PLANNING COMMITTEE REPORT

PLANNING COMMITTEE		AGENDA ITEM NO:
Date:	17 th November 2015	NON-EXEMPT

Application number	P2015/1204/FUL
Application type	Full Planning
Ward	Caledonian
Listed building	NA
Conservation area	NA
Development Plan Context	Locally significant industrial site Local Views (LV7) Kings Cross and Pentonville Rd Key Area (CS6) Article 4 Direction: B1a (office) to C3 (residential)
Licensing Implications	None
Site Address	22- 23 Tileyard Road, London, N7 9AH
Proposal	Re-configuration and refurbishment of existing two storey office building, a three storey roof extension and five storey side extension to create a total of 2,072sqm (GIA) of Class B1 space (net increase of 1,159 sqm (GIA) of accommodation).

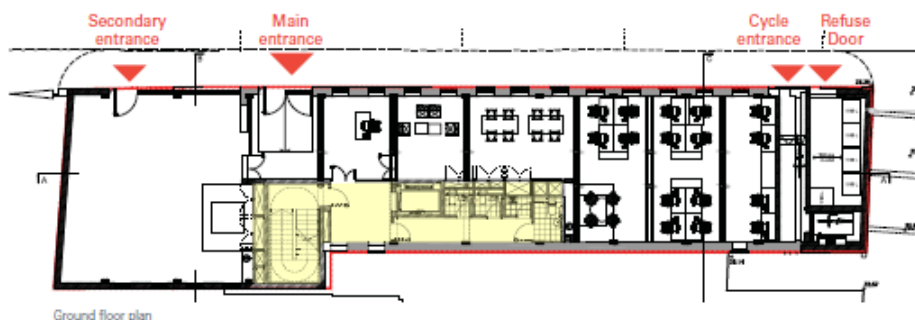
- 11.20 Small/ micro or affordable workspace: As part of any major office development the council will look to secure workspace suitable for small businesses – either through the way it is designed/managed (such as small unit sizes) or through securing affordable workspace (policies CS6, CS13 and DM5.4). Small workspace units are defined as between 50 and 90sqm and micro units between 10 and 50sqm. In terms of the uplift of floor area within

- 11.21 The applicant was initially unwilling to provide floorspace within the resulting building as suitable for either: micro / small units or an area of floorspace to be provided on affordable rent terms. However, revisions to the scheme have been made and the proposal now includes the creation of one unit suitable for small enterprises.

- 11.22 The unit is designed as a small unit, measuring 56sqm, designed with its own separate entrance from Tileyard Road, making it an individual, self-contained unit. In order to secure this, a condition is recommended (**condition 19**) stating that this unit shall be laid out in accordance with the details so approved and shall not be amalgamated with the remainder of the ground floor office unit. Additionally, this unit shall have access to the cycle storage and bin store of the main building and this access is secured by planning condition (**condition 20**). In this regard, the provision of a small unit meets the requirements of policy DM5.4 being affordable by virtue of its size.

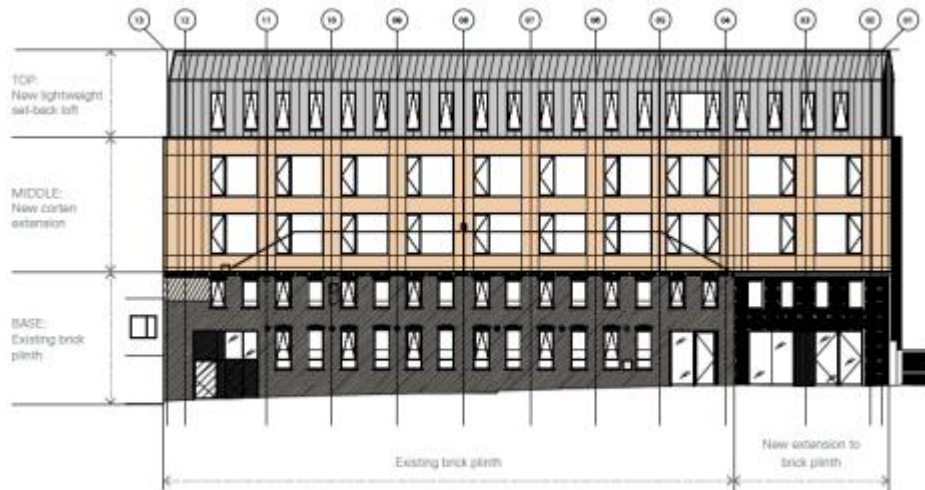
11.37 Windows: The initially proposed windows were considered by the Design and Conservation Officer to be “of a scale that alter the proportions of the building resulting in a top heavy appearance which is considered inappropriate. The lower levels with a much smaller fenestration pattern and overall scale are supporting the much larger storeys above, which is considered inappropriate in terms of design”. The initial proposal is illustrated below:

11.38 The scheme was amended to reduce the size of the windows in the top floor and to better respect general architectural hierarchy of windows moving to smaller windows moving up the façade of a building. That amended process is illustrated below:

11.39 Whilst the above amendments were felt to be an improvement, it was still felt by the Design and Conservation Officer that the middle floor windows still required further articulation, and would benefit from better referencing the narrower window widths above and below as a compromise on the size of windows had been agreed. In this regard, the image below illustrates how the middle floor windows were broken down into tripartite divisions. This change was also felt to retain references to the larger windows found in buildings within the surrounding industrial estate, and is the final proposal which is supported.
